# Road Safety Audit Response Report

<b>Report title:</b>	Lye Lane, Bricket Wood, Stage 1 RSA Response
<b>Date:</b>	27/09/22
<b>Document reference and revision:</b>	P2584 Stage 1 RSA Response v1
<b>Prepared by:</b>	Paul Mew Associates
<b>On behalf of:</b>	MRP Planning / JD Rudkin (Builders) Ltd

**Proposed S278 Highway Works**

**Stage 1 Road Safety Audit**

P2584: Land North of Bricket Wood, Herts  
 Proposed Site Access Junction Layout

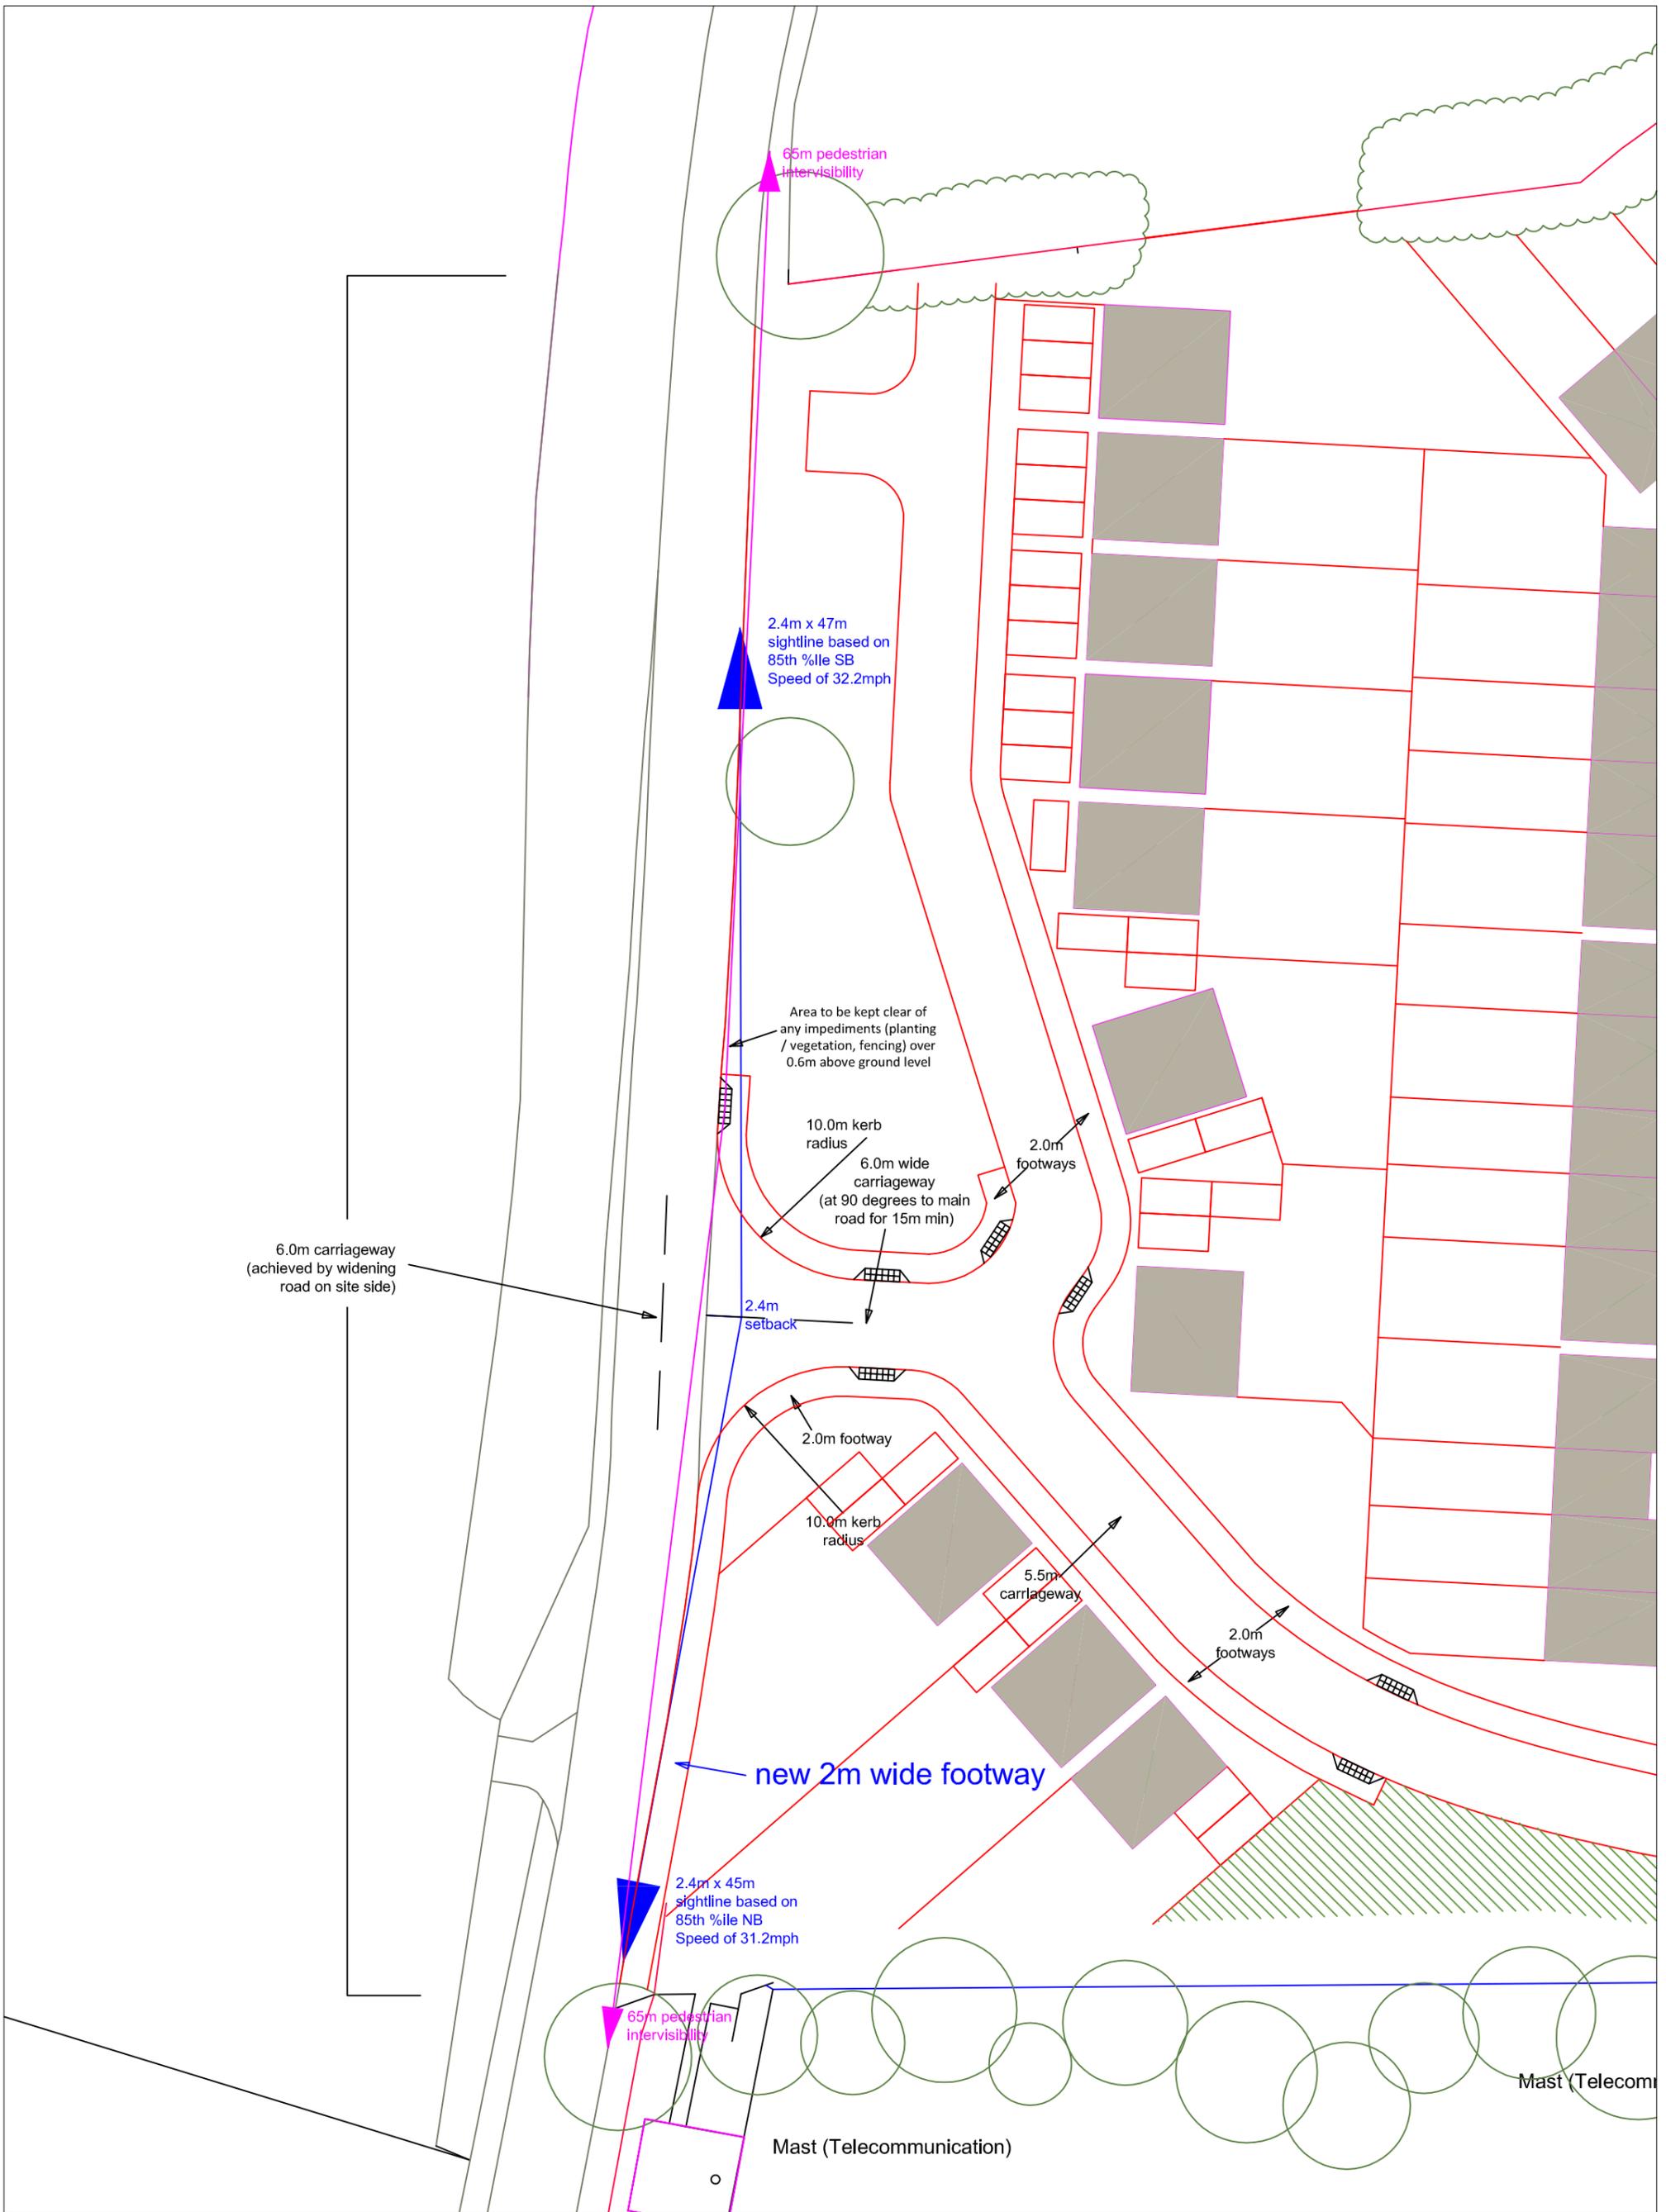
**Location:** A – Lye Lane, development site access junction.

**Summary:** Potential restricted visibility for motorists seeking to emerge from the development site access junction onto Lye Lane could result in a potential increased risk of side impact collisions occurring, whereby vehicle occupants could sustain personal injury.

It is evident from the scheme drawing that the 2.4m x 43m visibility splay to the north of the proposed development site access junction crosses the development site frontage denoted in green.

Concern arises that potential landscaping / fencing fronting the proposed development site could restrict visibility for motorists emerging from the development site access junction onto Lye Lane. The situation could be exacerbated as the 85<sup>th</sup> percentile speeds are slightly higher than the posted 30mph speed limit and the provision of 43m visibility splays. As a result, restricted visibility could lead to a potential increased risk of side impact collisions occurring, between vehicular traffic emerging from the development site and vehicular traffic on Lye Lane, whereby vehicle occupants could sustain personal injury.

It is recommended that the northern visibility splay should be kept clear of any impediments that may restrict visibility at this location.

Additionally, it is recommended that the proposed visibility splays should be commensurate with the 85<sup>th</sup> percentile speeds on Lye Lane.

**Location: B** – Lye Lane, development site access junction.

**Summary:** Swept path requirements of larger vehicles negotiating the proposed development site access junction could result in a potential increased risk of head on or side swipe type collisions occurring, whereby vehicle occupants could sustain personal injury.

It is evident from the scheme drawing that the Refuse Vehicle encroaches the centre lines within the proposed development site access junction and main carriageway of Lye Lane.

Concern arises that large vehicles including those mentioned above encroaching the centre lines within the development site access junction and Lye Lane when accessing and egressing the development site, could lead to a potential increased risk of head on or side swipe type collisions occurring with opposing flows of vehicular traffic, whereby vehicle occupants could sustain personal injury.

It is recommended that the junction geometry should be modified in order to mitigate the above described potential collision scenario.

**Locations: C, D and E** – Development site access junction.

**Summary:** Lack of dropped kerbs could result in a potential increased risk of pedestrian trips and falls occurring on the assumed full height kerb upstands, whereby pedestrians could sustain personal injury, especially those who are blind, visually or mobility impaired.

Concern arises that pedestrians negotiating the assumed full height kerb upstands when crossing the proposed access junction from north to south and vice-versa could lead to a potential increased risk of pedestrian trips and falls occurring, whereby pedestrians could sustain personal injury, especially those who may be blind, visually or mobility impaired.

It is recommended that dropped kerbs and tactile paving should be provided across the development site access junction, in order to mitigate the above described potential injury scenario.

**Location: F** – Footway to the north of the development site access junction.

**Summary:** Lack of dropped kerbs could result in a potential increased risk of pedestrian trips and falls occurring on the assumed full height kerb upstands, whereby pedestrians could sustain personal injury, especially those who are blind, visually or mobility impaired.

Concern arises that pedestrians negotiating the assumed full height kerb upstands when transitioning between the footway and carriageway to the north of the proposed development site access junction, could lead to a potential increased risk of pedestrian trips and falls occurring, whereby pedestrians could sustain personal injury, especially those who may be blind, visually or mobility impaired.

It is recommended that a length of dropped kerbs should be provided at this location, in order to mitigate the above described potential injury scenario.

**Location: G** – Footway to the north of the development site access junction.

**Summary:** Potential restricted inter-visibility for pedestrians transitioning from the footway to the carriageway could result in a potential increased risk of vehicle and pedestrian collisions occurring, whereby pedestrians could sustain personal injury.

It is evident from the scheme drawing that the proposed footway to the north of the development site access junction ends adjacent to the development site frontage denoted in green.

Concern arises that potential landscaping / fencing fronting the proposed development site could restrict inter-visibility between pedestrians transitioning between the footway and carriageway when walking northbound on Lye Lane and southbound vehicular traffic. As a result, this situation could lead to a potential increased risk of vehicular and pedestrian collisions occurring, whereby pedestrians could sustain personal injury.

It is recommended that the inter-visibility should be accurately measured and kept clear of any impediments that may restrict inter-visibility at this location, in order to mitigate the above described potential collision scenario.

RSA problem	RSA recommendation	Design organisation response	Overseeing Organisation response	Agreed RSA action
<p>Location: A – Lye Lane, development site access junction.            Summary: Potential restricted visibility for motorists seeking to emerge from the development site access junction onto Lye Lane could result in a potential increased risk of side impact collisions occurring, whereby vehicle occupants could sustain personal injury.</p> <p>The scheme drawing indicates the provision of a new access junction on the eastern side of Lye Lane, located to the north of the existing vehicular access for the paintball centre. The existing vehicular access is to be stopped up. The site visit has established that the posted speed limit on Lye Lane was 30mph, as indicated by repeater signs on posts.</p> <p>The recorded 85th percentile speeds on Lye Lane were 31.2mph for northbound vehicular traffic and 32.2mph for southbound vehicular traffic.</p> <p>It is evident from the scheme drawing that the 2.4m x 43m visibility splay to the north of the proposed development site access junction crosses the development site frontage denoted in green.</p> <p>Concern arises that potential landscaping / fencing fronting the proposed development site could restrict visibility for motorists emerging from the development site access junction onto Lye Lane. The situation could be exacerbated as the 85th percentile speeds are slightly higher than the posted 30mph speed limit and the provision of 43m visibility splays. As a result, restricted visibility could lead to a potential increased risk of side impact collisions occurring, between vehicular traffic emerging from the development site and vehicular traffic on Lye Lane, whereby vehicle occupants could sustain personal injury</p>	<p>It is recommended that the northern visibility splay should be kept clear of any impediments that may restrict visibility at this location.</p> <p>Additionally, it is recommended that the proposed visibility splays should be commensurate with the 85th percentile speeds on Lye Lane.</p>	<p>The northern visibility splay will be kept clear of any impediments (planting / vegetation, fencing) over 0.6m above ground level that may restrict visibility at this location. Sightlines have been amended to show requirements based on 85<sup>th</sup> %ile recorded speeds of 31.2mph NB – sightline requirement of 45m and 32.2mph SB – sightline requirement of 47m. Revised drawings are shown in Appendix B.</p>

<p>Location: B – Lye Lane, development site access junction.            Summary: Swept path requirements of larger vehicles negotiating the proposed development site access junction</p>	<p>It is recommended that the junction geometry should be modified in</p>	<p>Junction geometry has been amended and swept path analysis for the refuse vehicle and other large vehicle carried out. Revised drawings are shown in Appendix B.</p>

<p>Locations: C, D and E – Development site access junction.</p> <p>Summary: Lack of dropped kerbs could result in a potential increased risk of pedestrian trips and falls occurring on the assumed full height kerb upstands, whereby pedestrians could sustain personal injury, especially those who are blind, visually or mobility impaired.</p> <p>The scheme drawing indicates the provision of a new access junction on the eastern side of Lye Lane. The scheme drawing also indicates the provision of footways leading from the proposed development site onto the new footway provision on the eastern side of Lye Lane.</p> <p>Within the proposed development site, the scheme drawing indicates that the proposed footways either side of the development site access road end, resulting in pedestrians either crossing to the opposite footway or</p>	<p>It is recommended that dropped kerbs and tactile paving should be provided across the development site access junction, in order to mitigate the above described potential injury scenario.</p> <p>Additionally, it is recommended that uncontrolled pedestrian crossing facilities should be provided within the proposed development</p>	<p>Dropped kerbs / tactile paving / uncontrolled pedestrian crossing facilities have been introduced at various locations within the proposed development site. Revised drawings are shown in Appendix B</p>

<p>Location: F – Footway to the north of the development site access junction.</p> <p>Summary: Lack of dropped kerbs could result in a potential increased risk of pedestrian trips and falls occurring on the assumed full height kerb upstands, whereby pedestrians could sustain personal injury, especially those who are blind, visually or mobility impaired.</p> <p>The scheme drawing indicates the provision of a new access junction on the eastern side of Lye Lane. The scheme drawing also indicates the provision of footways leading from the proposed development site onto the new footway provision on the eastern side of Lye Lane.</p> <p>Concern arises that pedestrians negotiating the assumed full height kerb upstands when transitioning between the footway and carriageway to the north of the proposed development site access junction, could lead to a potential increased risk of pedestrian trips and falls occurring, whereby pedestrians could sustain personal injury, especially those who may be blind, visually or mobility impaired.</p>	<p>It is recommended that a length of dropped kerbs should be provided at this location, in order to mitigate the above described potential injury scenario.</p>	<p>A dropped kerb with tactile paving will be provided at this location. Revised drawings are shown in Appendix B</p>

<p>Location: G – Footway to the north of the development site access junction.</p> <p>Summary: Potential restricted inter-visibility for</p>	<p>It is recommended that the inter-visibility should be accurately measured</p>	<p>Intervisibility splay will be kept clear of any impediments (planting / vegetation, fencing) over 0.6m above ground level that may restrict visibility at this location.</p>
